**Re: Newfoundland and Labrador Hydro 2026 General Rate Application
Requests for Information of the Labrador Interconnected Group**

Requests for Information

by the Labrador Interconnected Group

LAB-NLH-001 to LAB-NLH-033

Chart 2: Labrador Interconnected System Annual Customer Coincident Demand Requirements^{12,13}

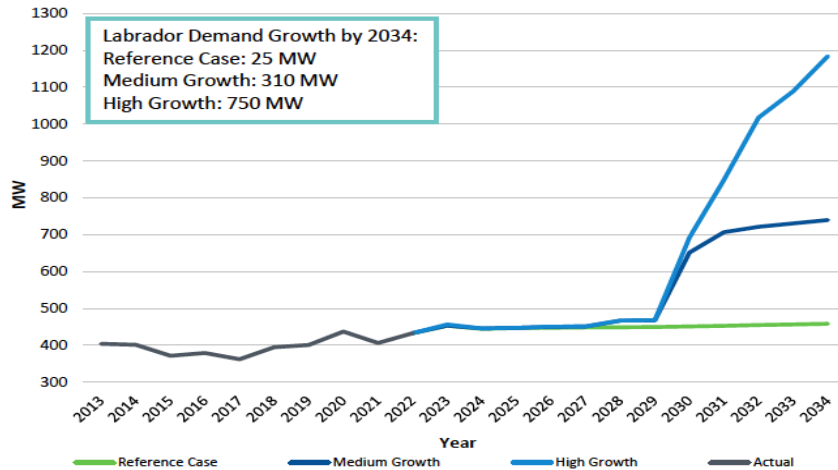
Table 1-1 in Volume 1 of the GRA indicates that Hydro proposes to smooth the rate increase in Labrador over the years 2027 through 2030 inclusive, and presumably any rate increases thereafter will be covered in a subsequent rate application. However, the 2023 Load Forecast for Labrador shows beginning in 2029 “the potential for significant load growth on that system [the LIS] stemming from existing Industrial customers.” If this magnitude and timing of load growth are still contemplated by Hydro, it is unclear what preparations are being made by NLH during the period covered by the current GRA (i.e. 2027-2030). Meeting a load growth of several hundred megawatts or more – whether through investments in new generation and transmission, recontracting of existing facilities, or some combination – would very likely entail significant rate increases for LIS customers.

The 2026 GRA LIS load forecast shows combined load growth for the Iron Ore Company of Canada and Tacora Resources of 6.9 MW and 38.3 GWh/year from 2024 to 2027.

- a) Is the load growth of IOC and Tacora described in the Preamble from 2024 to 2027 their desired load growth, or the constrained growth resulting from limitations on the Labrador West transmission network and/or from the lack of sufficient energy and capacity on the LIS?

- b) If it is the constrained load growth, would relieving these constraints result in substantially greater load growth?
- c) Please provide updated tabular and graphical actuals and forecasts from 2015 to 2035 for reference, medium and high growth scenarios for the LIS in terms of i) annual customer coincident demand and ii) annual energy demand.

Chart 2-10: Value for Customers Generated by Energy Marketing (\$ Millions)

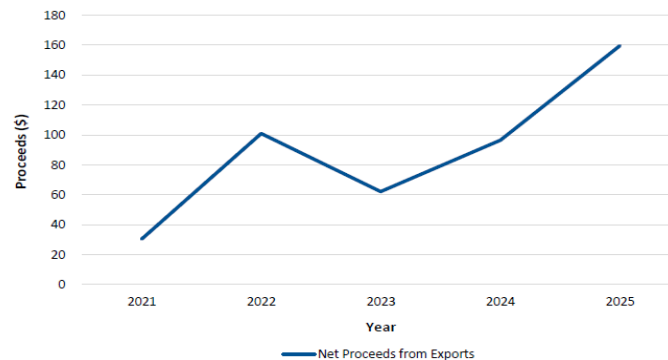
- a) Please present in tabular form the Energy Marketing costs (imports) and revenues (exports) resulting in the net proceeds shown in Citation 1, for each year from 2021 through 2025, inclusive;
- b) Please explain the regulatory and accounting treatment of both import costs and export revenues.
- c) Please explain, detail and quantify any benefits to LIS customers that result from Energy Marketing.
